Access Compliance Report Public Rights-of-Way (Curb Ramps)

Main Street: AIROSO_ST Cross Street: SUERTE_ST Location: SW

ADA ID: RPRK211130122150 Ramp Type: Type 4 - Parallel Initial Pass/Fail: Pass Overall Compliance: No Severity Score: 5

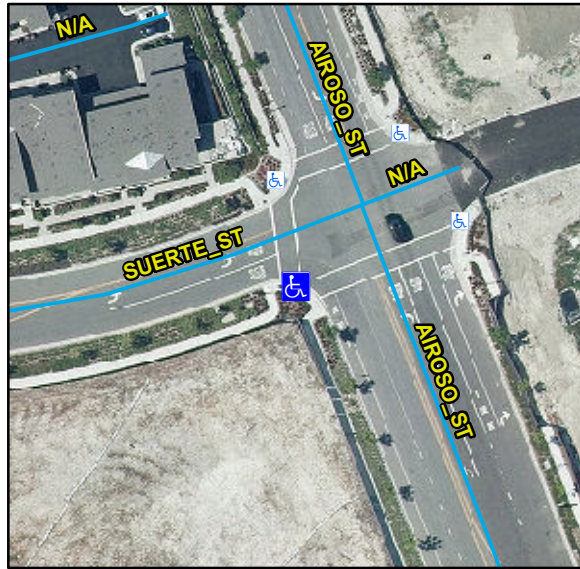
Yes	Ramp Inside Crosswalk 1	Yes	Yes	Ramp Inside Crosswalk 2	Yes
	Crossing 1 Slope (%)	2.7		Crossing 2 Slope (%)	2.3
	Crossing 1 Cross Slope (%)	2.5		Crossing 2 Cross Slope (%)	2
Yes	Gutter Ponding	No	Yes	Curb Slope	3.2
Yes	Gutter Lip Height (in)	0		Road Run Slope (%)	2.7
No	Gutter Run Slope (%)	5.5		Road Cross Slope (%)	5.6
Yes	Gutter Cross Slope (%)	1.9	Yes	Perpendicular Joint Present	Yes
Yes	Overall Surface Condition	Acceptable			
	Cross Gutter Present?	No		Spandrel Present?	No
	Replace Cross Gutter?	N/A		Replace Spandrel?	N/A

Remove & Replace Gutter.

R304.5.4, STD 1115
